CITY PLAN COMMISSION**THURSDAY OCTOBER 13, 2022****FILE NUMBER:** S212-354**SENIOR PLANNER:** Sharmila Shrestha**LOCATION:** Virginia Avenue, south of Fitzhugh Avenue**DATE FILED:** September 23, 2022**ZONING:** MF-2(A)**CITY COUNCIL DISTRICT:** 2 **SIZE OF REQUEST:** 0.208-acre**MAPSCO:** 46A**OWNER:** AHC Funds

REQUEST: An application to replat a 0.208-acre tract of land containing a part of Lot 1 and all of Lot 2 in City Block B/709 to create one lot on property located on Virginia Avenue, south of Fitzhugh Avenue.

<p>1:2,400</p>	<p>EXISTING AREA ANALYSIS MAP</p> <ul style="list-style-type: none"> <input type="checkbox"/> Area of Request <input type="checkbox"/> Recent History 	<p>Case no: S212-354</p> <p>Date: 9/28/2022</p>
--	--	---

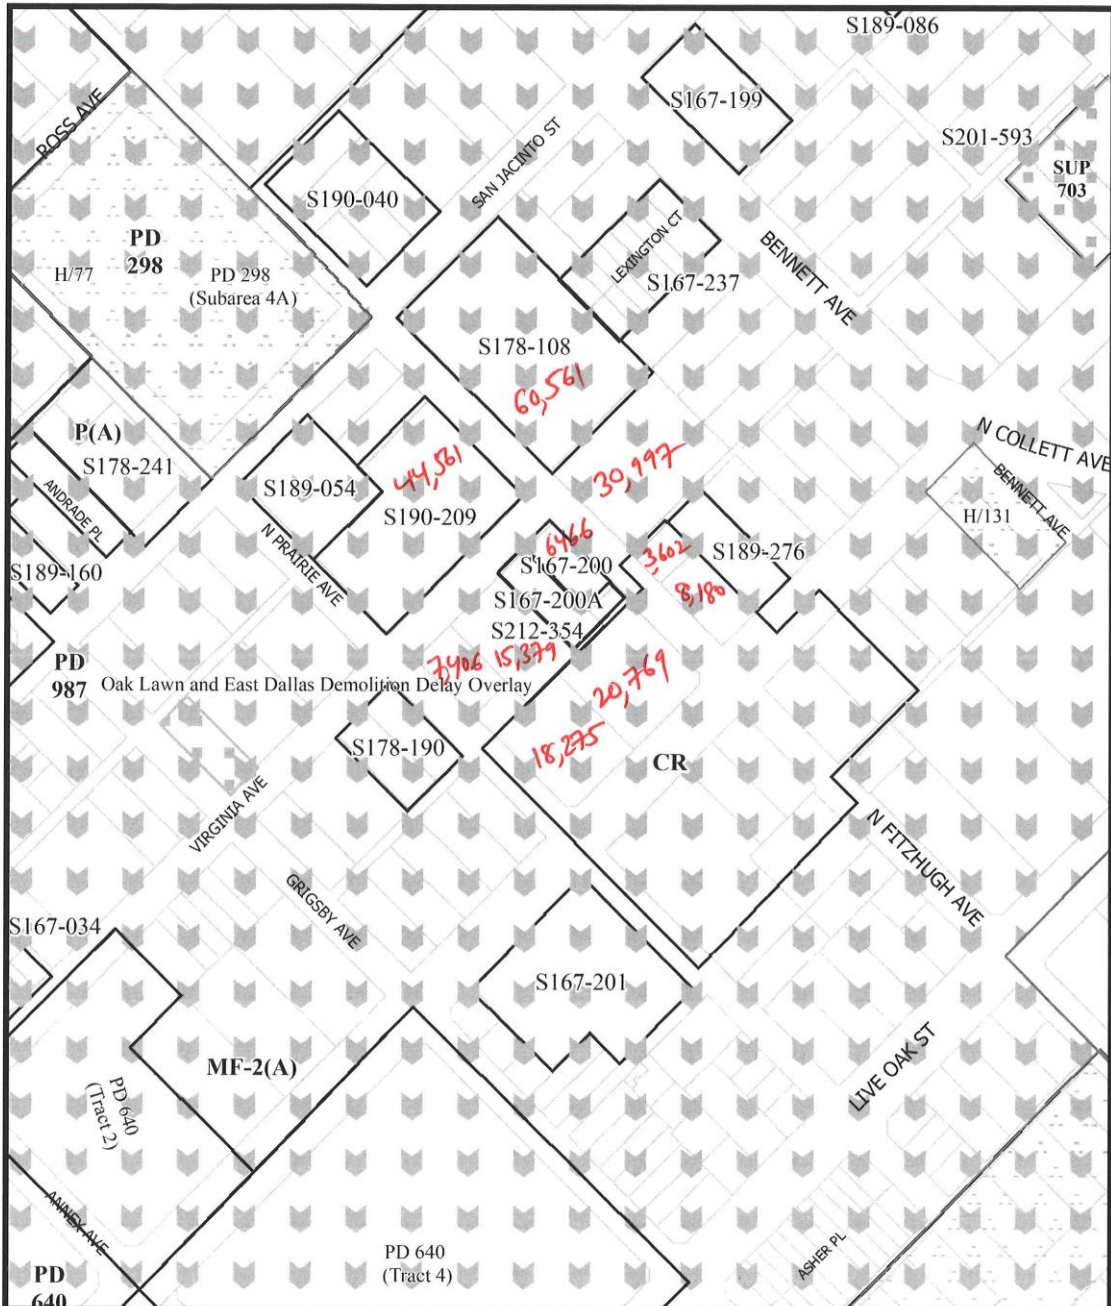
Considering the variety of lot widths and lot areas in the immediate area of the request (*refer to the existing area analysis map*), staff concludes that there is no uniform lot pattern and the request complies with the requirements of Section 51A-8.503 and the MF-2(A) Multi Family District; therefore, staff recommends approval of the request subject to compliance with the following conditions:
